PIC18F8720/8620/6720/6620 Rev. A4 Silicon/Data Sheet Errata

The PIC18F8720/8620/6720/6620 parts you have received conform functionally to the Device Data Sheet (DS39609B), except for the anomalies described below.

In the Device Data Sheet (DS39609B), the following clarifications and corrections should be noted.

FIGURE 26-3: PIC18F6620/6720/8620/8720 VOLTAGE-FREQUENCY GRAPH (INDUSTRIAL, EXTENDED)

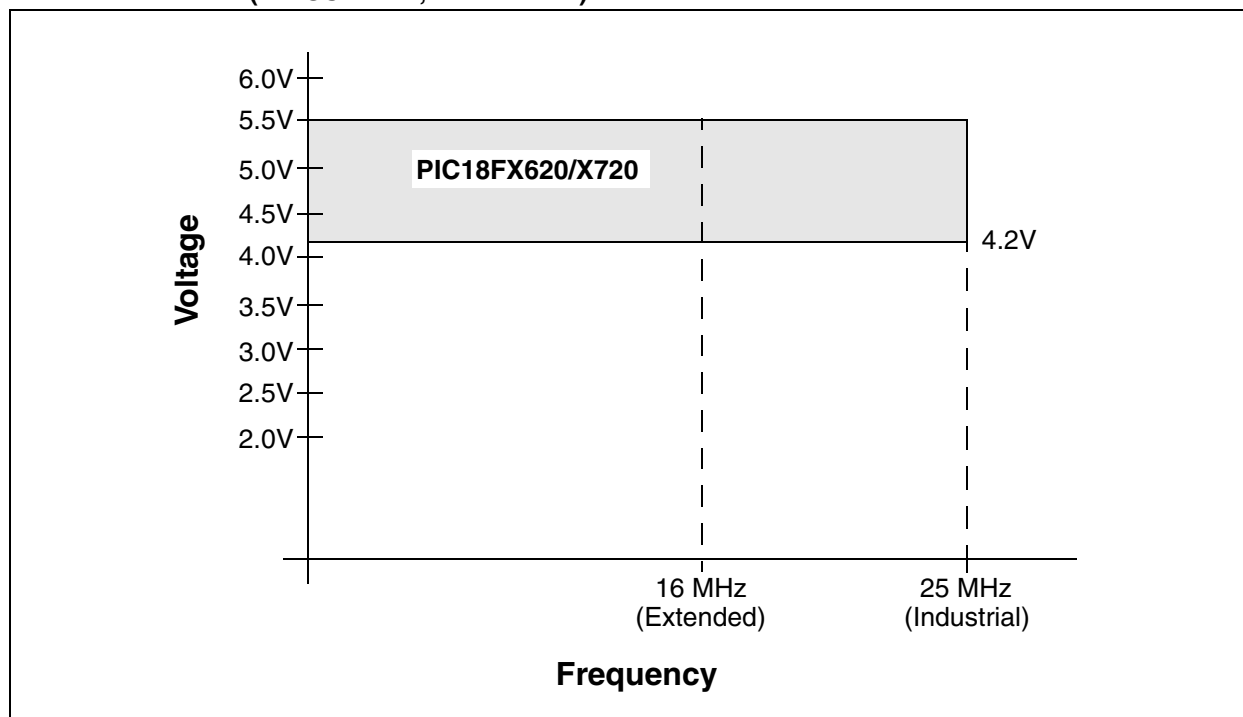
1. Module: Voltage-Frequency Graph

In Section 26.0 “Electrical Characteristics”, the following figure has been updated to clarify the voltage frequency for Extended devices.

FIGURE 11-1: TIMER0 BLOCK DIAGRAM IN 8-BIT MODE

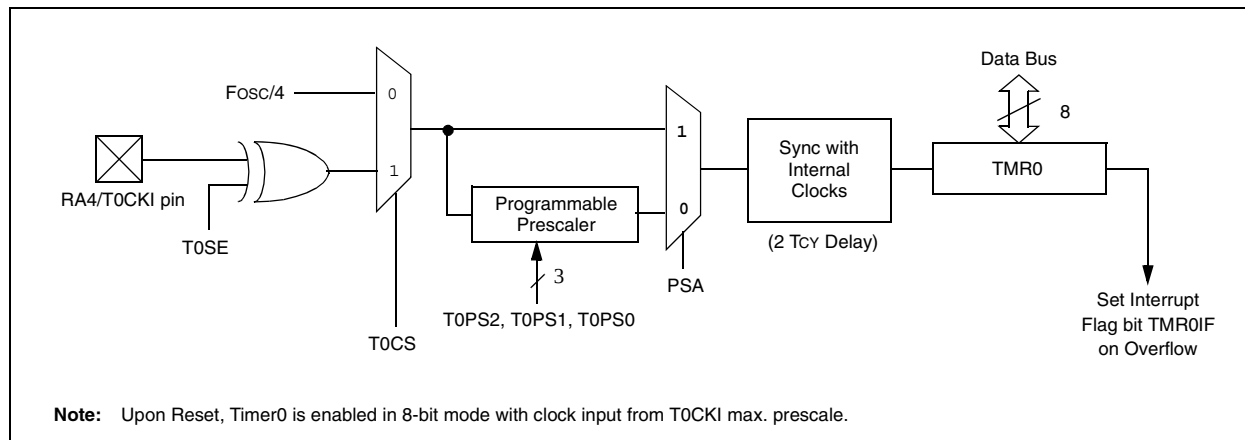
10. Module: Timer0 Block Diagram in 8-Bit and 16-Bit Modes

The PSA multiplexor bit values in Figures 11-1 and 11-2 do not match the text description of the Timer0 PSA bit in the T0CON register.

The bit values have been corrected by swapping the values as shown below (correct values are shown in **bold text**):
